Department of Energy

Enclosed is our "Response to NRC Comment on Settlement" at the Ambrosia Lake, New Mexico, Uranium Mill Tailings Remedial Action disposal site. Also enclosed is the survey data for the settlement monuments.

Response to NRC Comment on Settlement

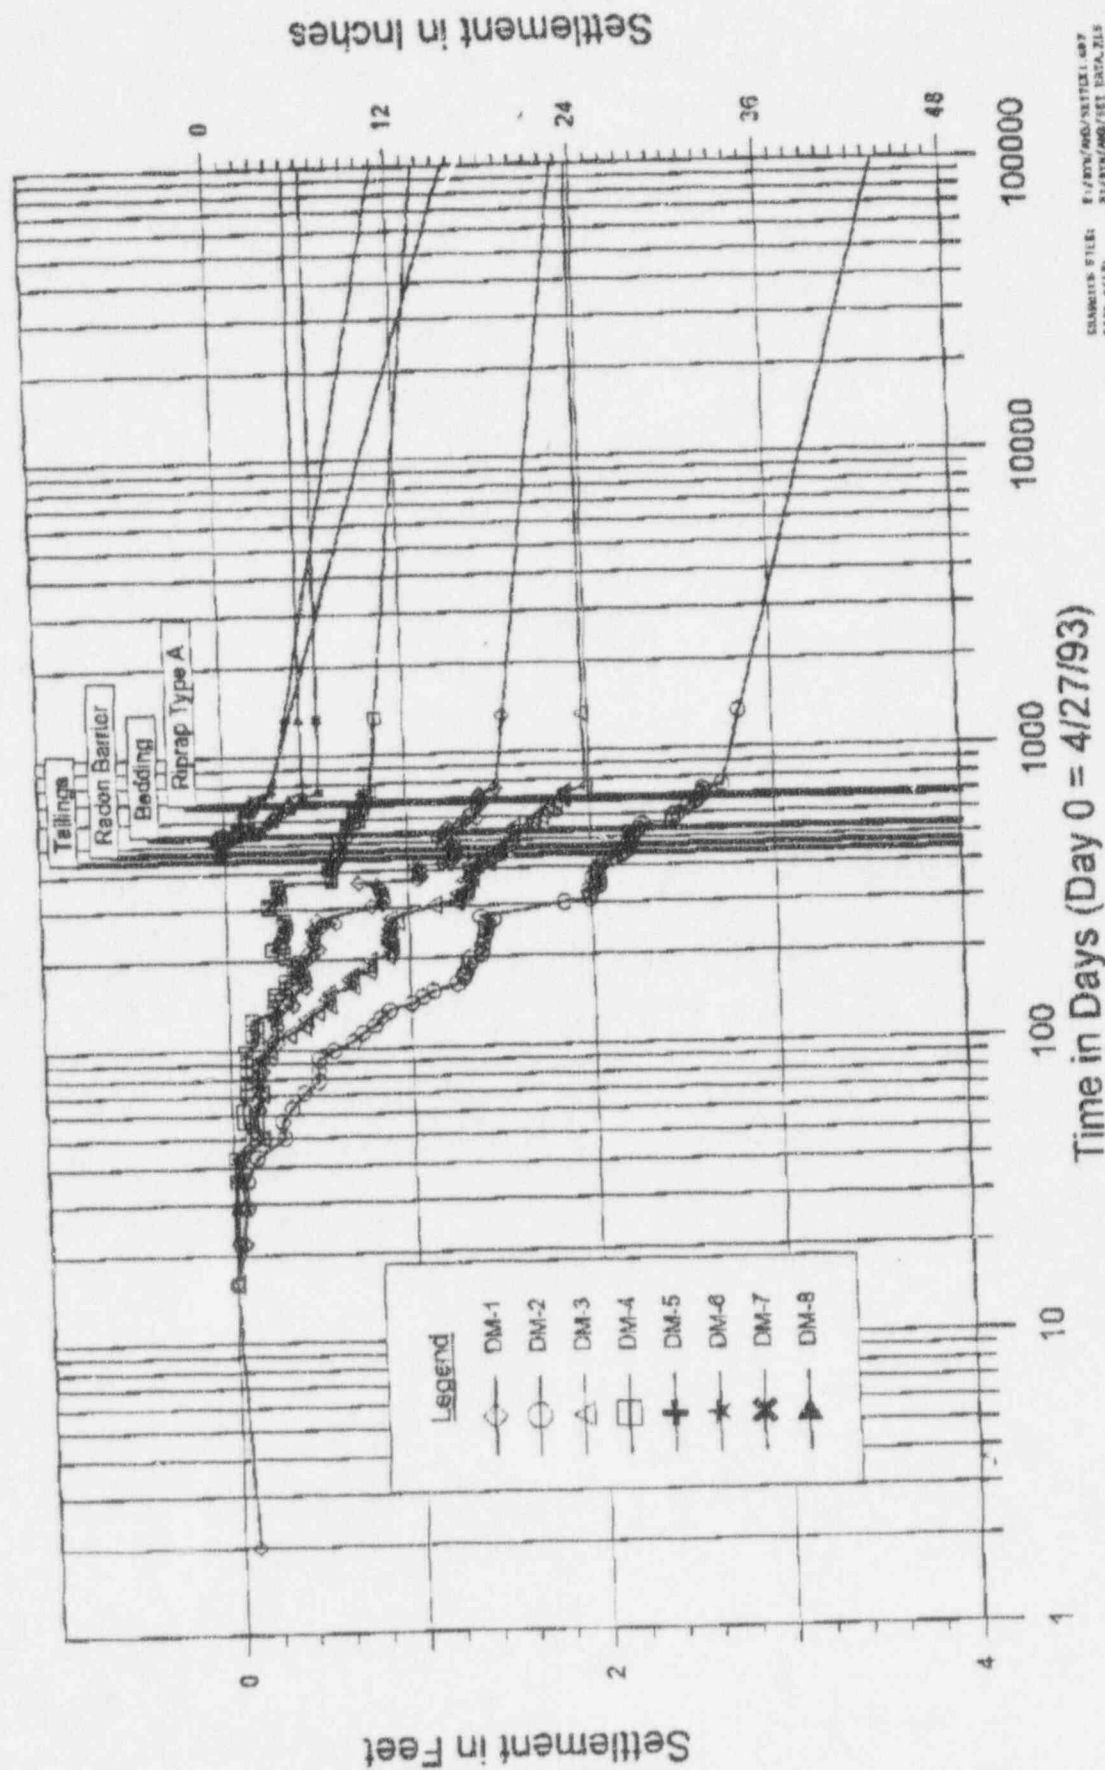
The settlement data presented in Figures 1 through 9 show that settlement due to primary consolidation was essentially complete at the end of construction. In Figure 9, where the data is plotted on semi-log paper, it is particularly evident that the rate of settlement changes dramatically at the end of construction. The last two settlement readings have been used to extrapolate the rate of secondary compression and to predict the long-term (1000 yr.) settlement of the disposal cell. This information has been used to develop confidence that the cell is performing as expected with respect to settlement and that routine settlement monitoring is not necessary as part of the long-term surveillance.
